Access Compliance Report Public Rights-of-Way (Curb Ramps)

Intersection ID: 10019873 Main Street: ARCHDALE_DR Cross Street: N/A Location: SE

ADA ID: 9DAC4F26CF51 Ramp Type: PerpDiag Initial Pass/Fail: Fail Overall Compliance: No Severity Score: 12.5

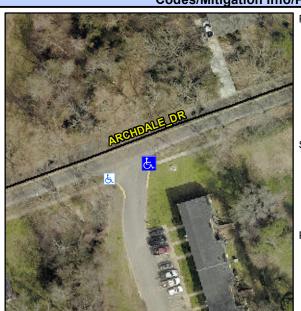
Not Found, R304.2.2

Field Measurements/Component Compliance						
	Compliance Description		Data	Compliance Description		Data
	N/A	Ramp Length (in)	44.0	No	Ramp Slope (%)	9.2
	Yes	Ramp Width (in)	48.0	Yes	Ramp XSlope (%)	0.5
	N/A	Flare Type LT	N/A	N/A	Flare Type RT	N/A
	N/A	Flare Slope LT (%)	N/A	N/A	Flare Slope RT (%)	N/A
	N/A	Flare Traversable LT?	N/A	N/A	Flare Traversable RT?	N/A
	N/A	Landing Length (in)	N/A	N/A	DWS Provided?	N/A
	N/A	Landing Width (in)	N/A	N/A	DWS Contrast?	N/A
	N/A	Landing Slope (%)	N/A	N/A	DWS Length (in)	N/A
	N/A	Landing X Slope (%)	N/A	N/A	DWS Full Width?	N/A
	N/A	Landing Curb? (Y/N)	N/A	N/A	DWS Offset (in)	N/A
	N/A	Shared Landing?	N/A			
	N/A	Gutter Ponding?	N/A	N/A	Gutter Slope (%)	N/A
	N/A	Gutter Lip Ht (in)	N/A	N/A	Gutter X Slope (%)	N/A
	N/A	Painted X Walk1?	No	N/A	Painted X Walk2?	No
		X Walk 1 Direction	To N		X Walk 2 Direction	To W
	N/A	X Walk 1 Width (in)	N/A	N/A	X Walk 2 Width (in)	N/A
		X Walk 1 Slope (%)	2.5		X Walk 2 Slope (%)	2.6

Remove & Replace Curb Ramp With
Two New Directional Ramps or
Equivalent.
